Monticello Nuclear Generating Plant
Docket 50-263
Renewed Operating License No. DPR-22

License Amendment Request: Application for Technical Specification Change
TSTF-427, Add Limiting Condition for Operation 3.0.9 Regarding the Unavailability of
Barriers Using the Consolidated Line Item Improvement Process

**ADD LCO 3.0.9 REGARDING THE UNAVAILABILITY OF BARRIERS
USING THE CONSOLIDATED LINE ITEM IMPROVEMENT PROCESS**

Figure B 3.0-1
Configuration of Divisions and Systems

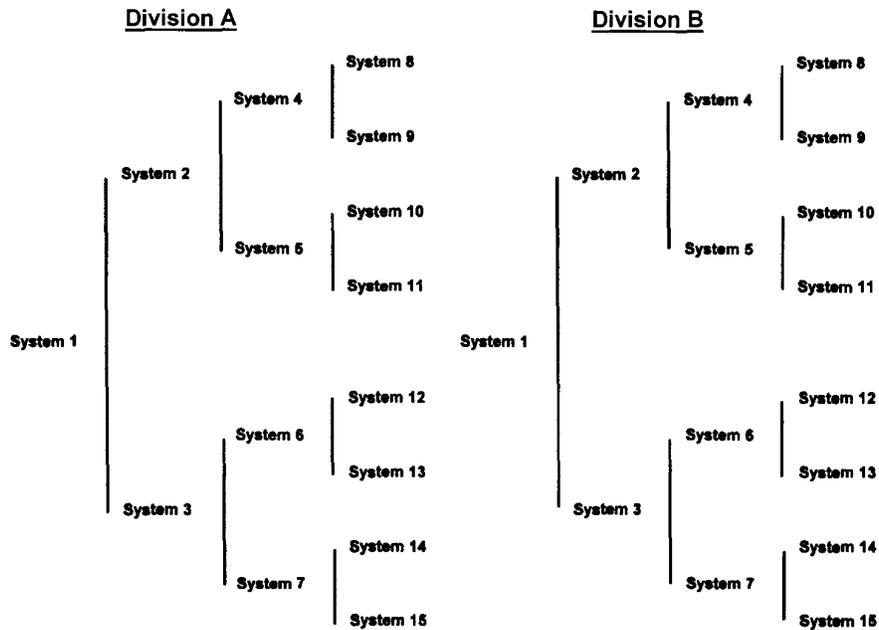
LCO 3.0.9 may be applied to one or more divisions or subsystems of a system supported by barriers that cannot provide their related support function(s), provided that risk is assessed and managed (including consideration of the effects on Large Early Release and from external events). If applied concurrently to more than one division or subsystem of a multiple division or subsystem supported system, the barriers supporting each of these divisions or subsystems must provide their related support function(s) for different categories of initiating events. For example, LCO 3.0.9 may be applied for up to 30 days for more than one division of a multiple division supported system if the affected barrier for one division protects against internal flooding and the affected barrier for the other division protects against tornado missiles. In this example, the affected barrier may be the same physical barrier but serve different protection functions for each division.

The High Pressure Coolant Injection (HPCI) and Reactor Core Isolation Cooling (RCIC) systems are single train systems for injecting makeup water into the reactor during an accident or transient event. The RCIC system is not a safety system, nor required to operate during a transient, therefore, it does not have to meet the single failure criterion. The HPCI system provides backup in case of a RCIC system failure. The Automatic Depressurization System (ADS) and low pressure Emergency Core Cooling System (ECCS) coolant injection provide the core cooling function in the event of failure of the HPCI system during an accident. Thus, for the purposes of LCO 3.0.9, the HPCI system, the RCIC system, and the ADS are considered independent subsystems of a single system and LCO 3.0.9 can be used on these single division systems in a manner similar to multiple division or subsystem systems.
